BELLEWOOD SUBDIVISION

RECOMMENDATION Due to the various revisions needed on the plat, this application is recommended for holdover to the July 20th meeting to allow the applicant to address the following items:

Revised for the July 20th meeting:

DETAIL SITE PLAN

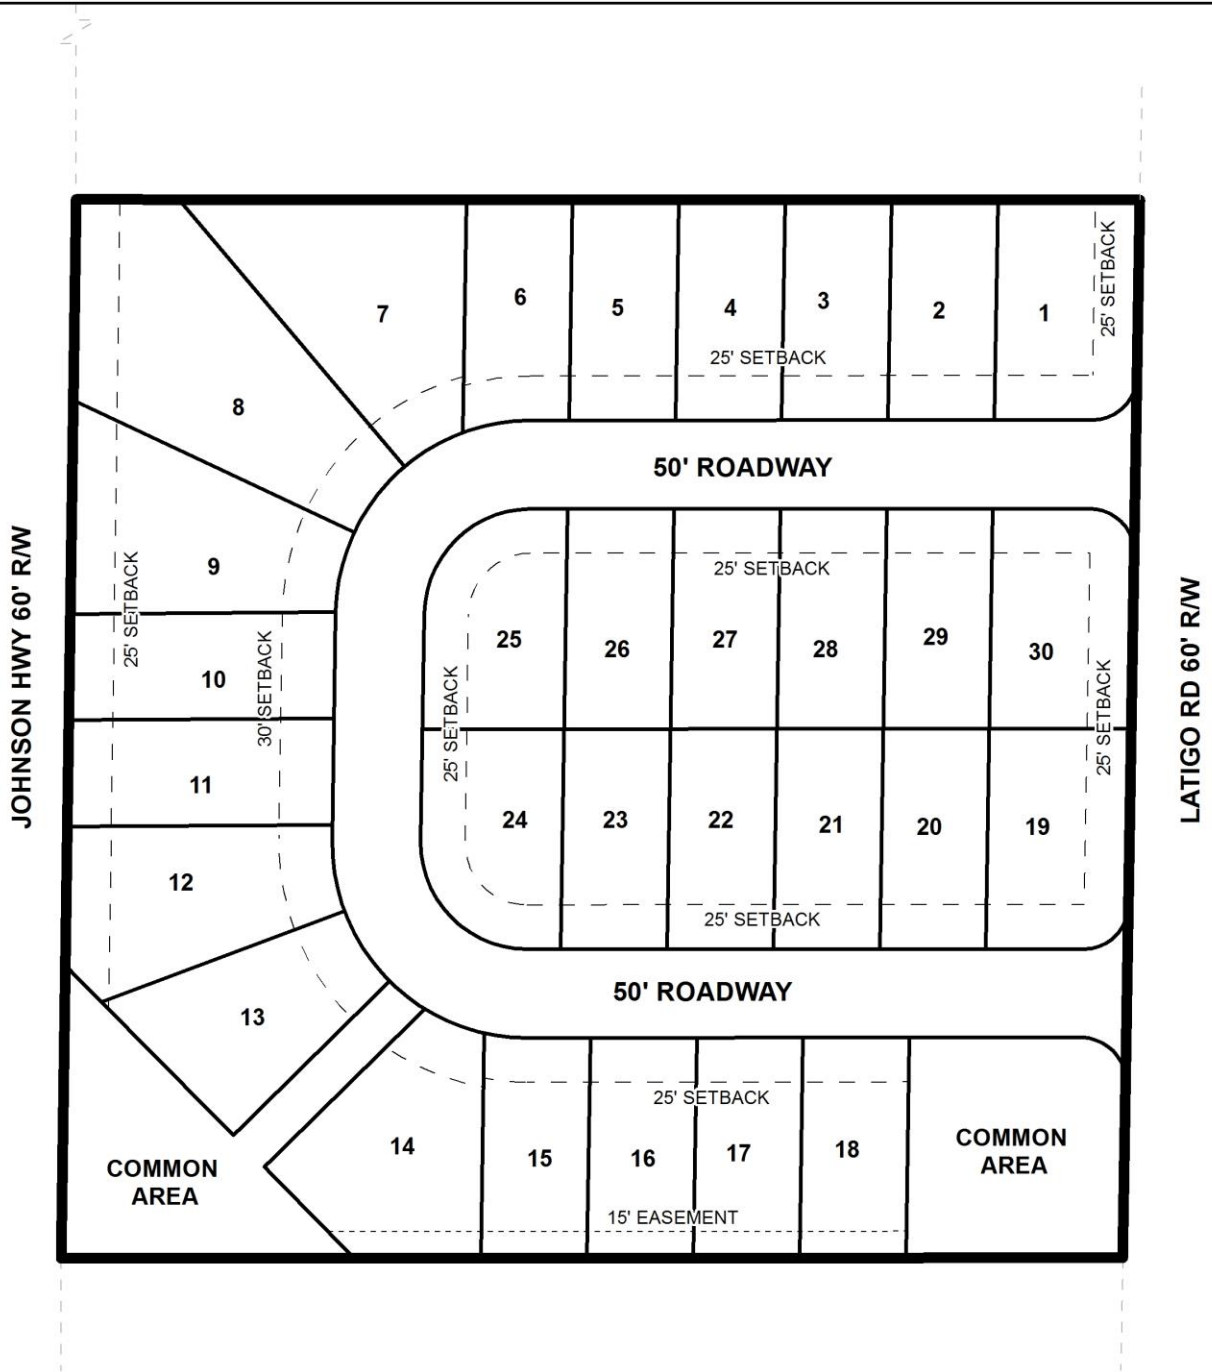
The plat indicates only a 20' minimum building setback line along Latigo Road, and for Lots 24 and 25 in the interior of the site. No justification for reduced setbacks as they pertain to an innovative subdivision has been provided. Therefore, the plat should be revised to illustrate the 25' minimum building setback line along all street frontages.

Access management is a concern along Latigo Road; therefore, a note should be required on the Final Plat, if approved, stating that Lots 1, 19, 30 and the Southeastern Common Area are denied access to Latigo Road. The plat does not indicate any designated access to the Southwestern Common Area; therefore, the plat should be revised to provide dedicated access to the Southwestern Common Area. This will require a 25' road frontage along the proposed street and may require the relocation of the 25' minimum building setback line on some lot(s) so as to be located where the lot(s) can be at least 60' wide at the setback line. All lots and the Common Areas should be limited to one curb cut each, with the size, location and design to be approved by Mobile County Engineering and conform to AASHTO standards.

Lots are labeled with their areas in square feet only. Therefore, the plat should be revised to label each lot with its size in both square feet and acres, or a table should be furnished on the Final Plat providing the same information.

The site has property lines at an intersection corner. Section V.D.6. of the Subdivision Regulations requires that "property lines at street intersection corners shall be arcs having radii of at least 10 feet or shall be chords of such arcs." As no curve data is provided for these entrances, the plat should be revised to indicate compliance with the Section V.D.6. Curve data is provided on the plat for three curves, but there is no corresponding identification of the specific curves. Therefore, the plat should be revised to identify the location of the curves for which the data is provided.

- 1) revision of the plat to illustrate a 25' minimum building setback along all street frontages for all lots;
- 2) revision of the plat to provide a 25' dedicated access to the Southwestern Common Area;
- 3) possible revision of the plat to ensure the building setback line is located at a point where lots are at least 60' wide for any lot(s) revised to provide the 25' frontage for the Southwestern Common Area;
- 4) revision of the plat to provide curve data for the subdivision entrance curves in compliance with Section V.D.6. of the Subdivision Regulations; and
- 5) revision of the plat to provide identification of the three curves for which curve data is given.

The applicant provided a revised plat which addressed all of the above. As revised, the plat meets the minimum requirements of the Subdivision Regulations and can be considered for approval, assuming public sewer service will become available.

The plat meets the minimum requirements of the Subdivision Regulations and is recommended for tentative approval, subject to the following conditions:

- 1) provision of public sewer service prior to signing the Final Plat;*
- 2) furnishing of a County Letter of Acceptance for the constructed streets prior to signing the Final Plat;*

- 3) retention of the 25' minimum building setback line along the rear of Lots 8 through 13;*
- 4) placement of a note on the Final Plat stating that Lots 8 through 13 and the Southwestern Common Area are denied access to Johnson Highway (private road);*

- 5) retention of the 25' minimum building setback line along Lots 1 through 6, and Lots 15 through 30;*
- 6) retention of the 30' minimum building setback line along Lots 7 through 14;*

- 7) placement of a note on the Final Plat stating that Lots 1, 19, 30 and the Southeastern Common Area are denied access to Latigo Road;*
- 8) placement of a note on the Final Plat stating that all lots and the Common Areas are limited to one curb cut each, with the size, location and design to be approved by Mobile County Engineering and conform to AASHTO standards;*

- 9) revision of the plat to label all lots and the Common Areas with their sizes in both square feet and acres, or the furnishing of a table on the Final Plat providing the same information;*

- 10) placement of a note on the Final Plat stating that the maintenance of the Common Areas is the responsibility of the property owners;*
- 11) retention of the entrance curve data on the Final Plat;*

- 12) placement of a note on the Final Plat stating that no structure may be placed or constructed within the 15' drainage easement along the South side of the subdivision;*
